MK 14 MOD 2 Corrective Action Status / Evaluation Results to Date 27 June 2012
Reference Task List from POA&M Scope/Mount/Precision/Function Issues w/ details:

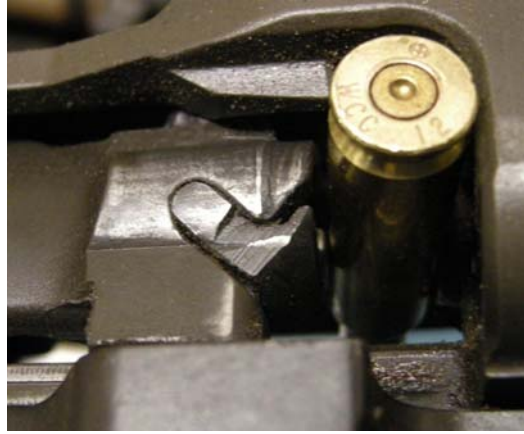
Results: 16 of the rifles more recently returned under the -8975 NSN were inducted and brought to the SWAF. Most of those were evaluated in some manner in an attempt to help determine factors involved in the potential loss of the extractor during firing. The rifles included a mix of the older M14 Sniper Kit or Sniper Security Rifles (Black Stock) and the Grey and Tan Stocked M14 SSR configurations. It was noted that several rifles had modified extractors (all at the top to apparently eliminate potential barrel (shroud) interference. One of the current tan stocked SSR's even had this modification (-7198). All these rifles turned in with modified extractors were test fired with new unmodified extractors and did not have any functional issues (related to the extractor – there were two of the magazine used that were found to be at fault for the failure that did occur – fail to lock back after last shot and failure to pick up next round). There was also no apparent correlation between tight headspace (at minimum 1.630") and any extractor issues.
